Apple No. 10/796,597
Amdt date July 16, 2007
Reply to Office action of April 16, 2007

Amendments to the Drawings:

REMARKS/ARGUMENTS

FIG. 1
(PRIOR ART)

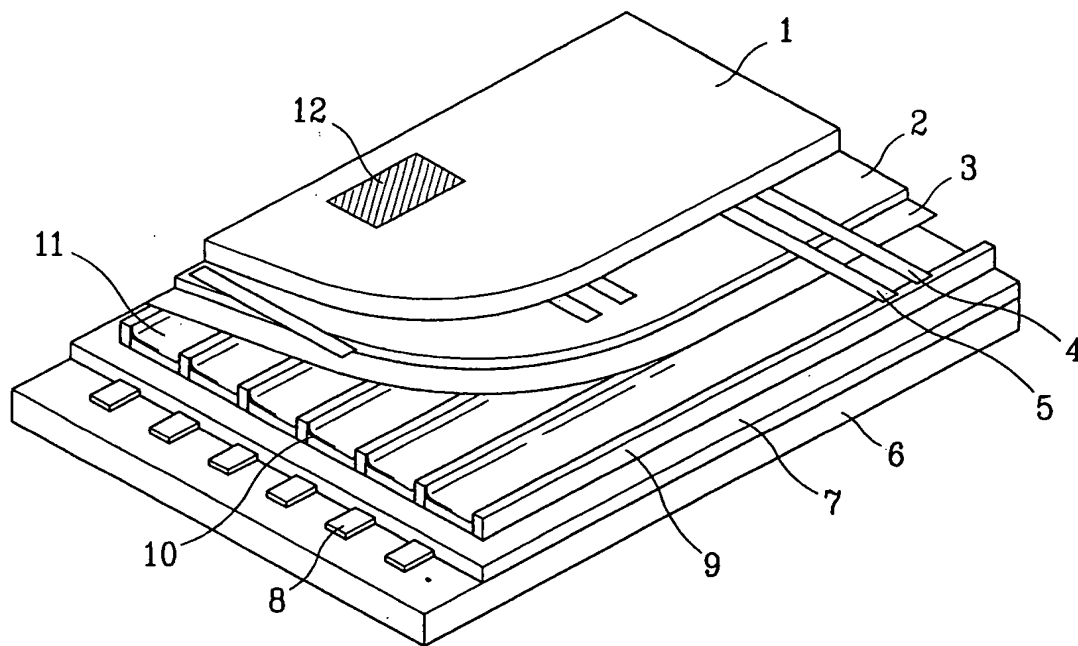
Figures 1, 2 and 3 are objected to for not including the legend "Prior Art." Figures 1, 2 and 3 are being amended to include the legend "Prior Art." Applicants submit herewith corrected drawing sheets together with annotated drawing sheets. As such, Applicants request that the objection to the drawings be withdrawn.
